Docket No. 52-011

AR-07-006 1

Southern Nuclear Operating Company
Vogtle Early Site Permit Application
Response to Reauests for Additional Information on the Environmental Report

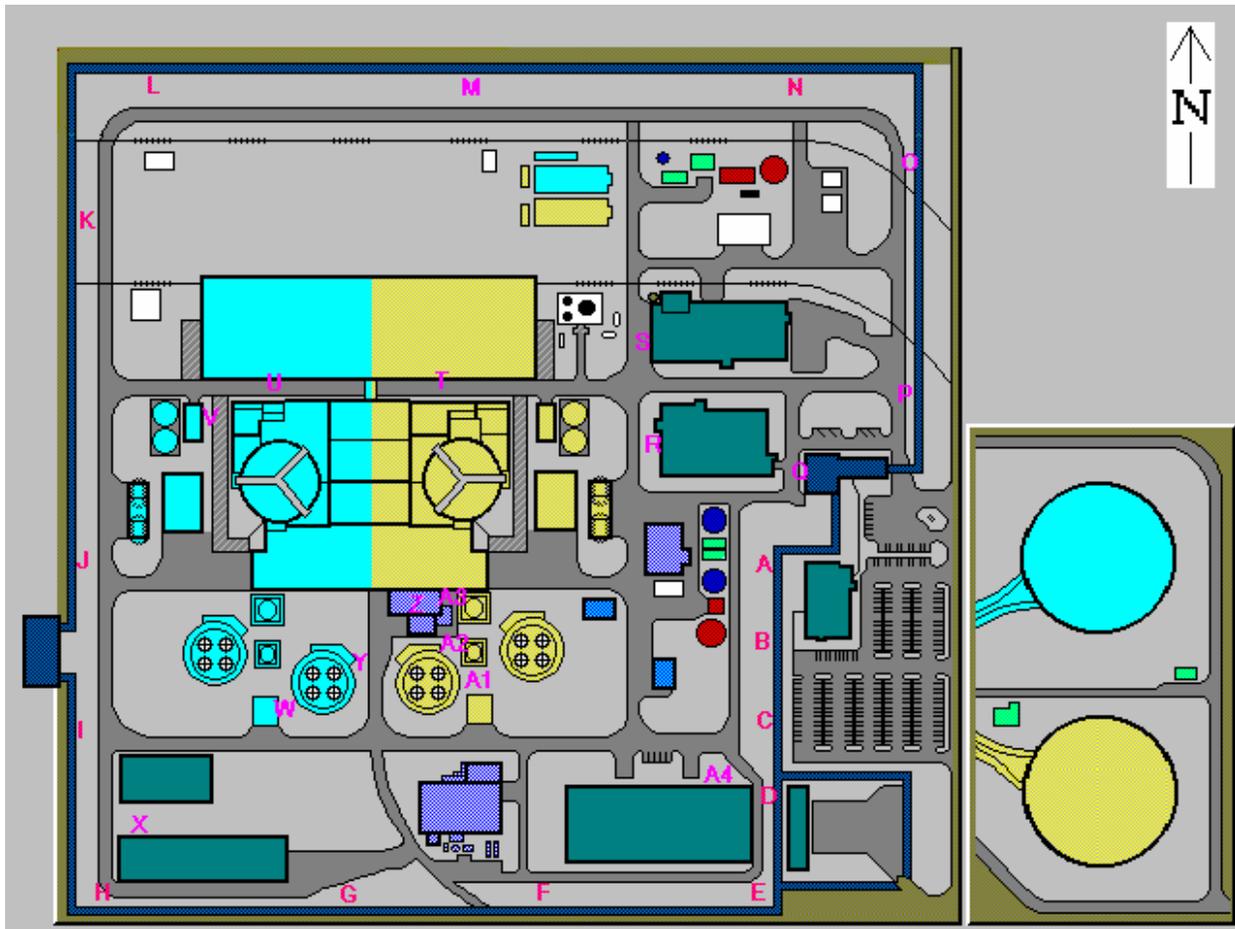
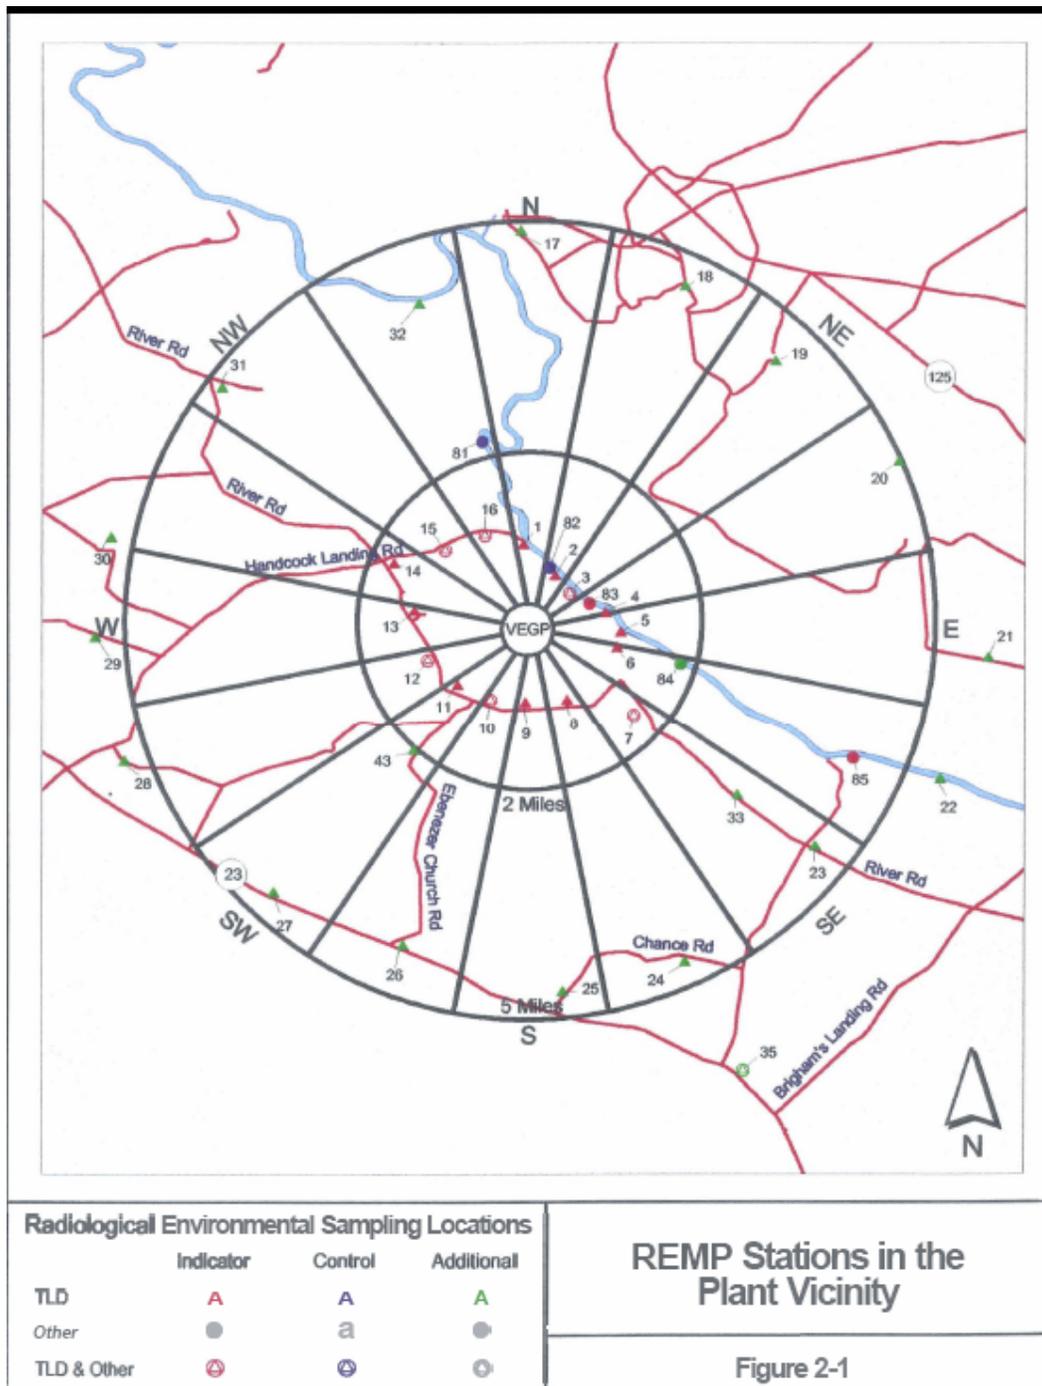
E4.5-1 Section 4.5 Radiation Exposure to Construction Workers Provide a site map indicating the location of the internal and general area TLD's used to estimate the annual direct radiation dose to the construction workforce of 50 mrem which is listed in Section 4.5.3.1 of the ER.

Following is a site map indicating the location of the TLD's used to determine the dose estimate at the Protected Area Fence closest to the construction site at VEGP Units 1 & 2. The TLD's used to determine this dose estimate are at Stations G, H, I, J, K and L.

Following is a site map indicating the location of the TLD's used to determine the background dose estimate. The TLD's used to determine the background dose estimate were inner-ring Stations 1-16.
